TECHNICAL SERVICE BULLETIN

Title: Cab Tilt Velocity Fuse 4-Door Cab, Full Tilt

Date: August 20, 2019

Problem: See Recall NHTSA 19V528 / Transport Canada 2019344

Figure 5 Velocity Fuse Close-up

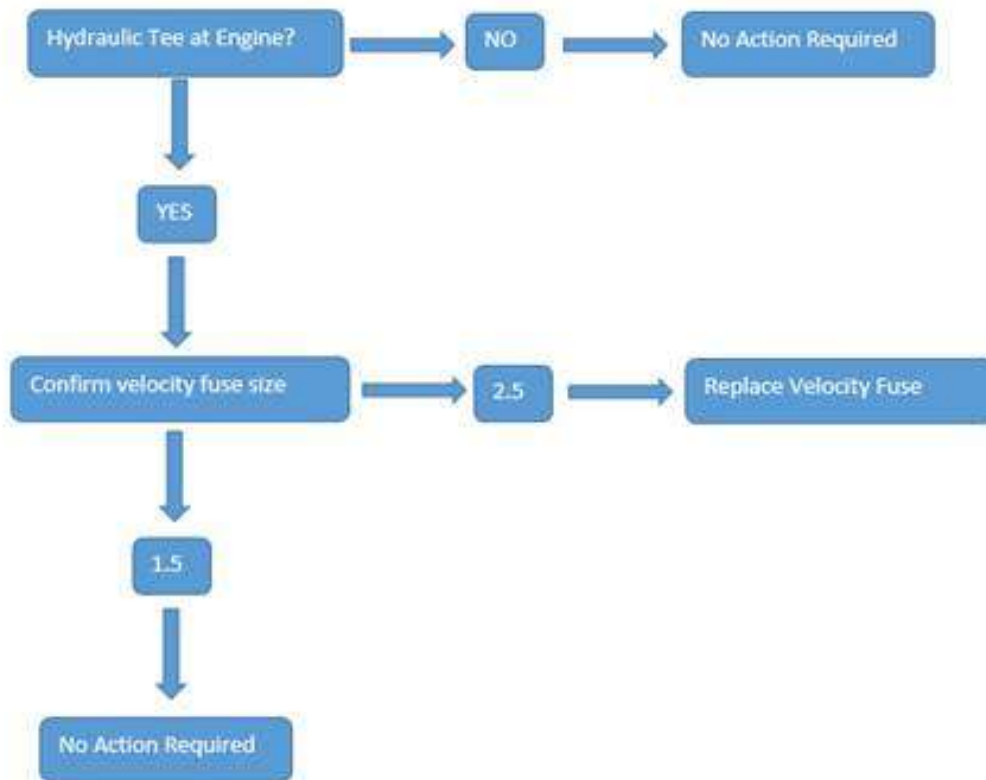
6. Ensure that the closing flow is 1.5; if so, no further action is required. Go to lowering the cab instructions.

If the fuse is 2.5, the fuse must be replaced with a 1.5 closing flow fuse. Go to Step 7.

KME Parts Required: If necessary, (2) - 1.5 (113861V) Closing Flow Velocity Fuses
